PUBLIC UTILITIES COMMISSION

August 29, 2017

RE: CEQA Data Request No. 4 for the San Diego Gas & Electric (SDG&E) and Southern California Gas Company (SoCalGas) Pipeline Safety and Reliability Project (PSRP) – New Natural Gas Line 3602 and De-Rating Line 1600

**Attachment 1: SDG&E and SoCalGas Pipeline Safety and Reliability Project – New Natural Gas Line 3602 and De-rating Line 1600
Data Request No. 4 (August 29, 2017)**

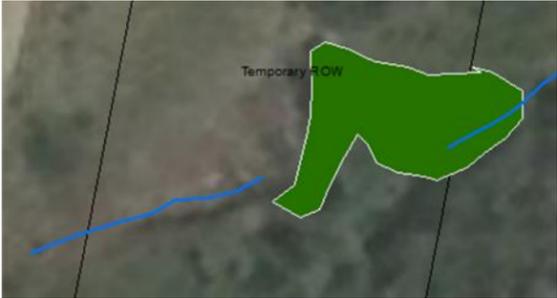
DG #	Resource / Topic Area	Source / PEA Page	Deficiency Item / Data Gap Question	Request Date	Reply Date	Status	Notes
Project Description							
DG 2-7 Follow Up 1	Project Description	Project description data included in the 6-23-2017 "PSRP_Facilities" and the 6-23-2017 "PSRP_ImpactLayer" layers	<p>At MP27.5, the centerline of L3602 (dotted red line) appears to leave the construction workspace (temporary ROW) (solid red line) as shown below.</p> <p>1) confirm if this is correct and explain why temporary workspace would not be needed around the centerline at this MP, or</p> <p>2) provide an updated centerline and/or impacts file to correct this.</p> 	8/29/2017

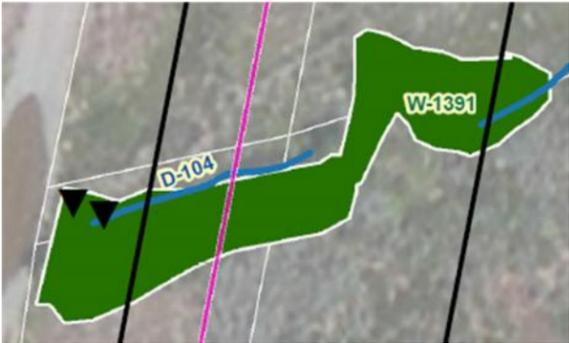
Biological Resources							
DG 4.4-1 Follow Up	Biological Resources	Wetlands Delineation Report submitted 2/10/17	Please provide GIS data for formal wetland delineation. The GIS data provided in October of 2015 does not match the figures attached to the 2017 Wetland Delineation Report. See screenshots below. The first image represents the wetland data that was submitted 10-1-2015, in the "Wetlands_Waters.shp" file. The second image is from the February 2017 Wetland Delineation Report. 	8/29/2017
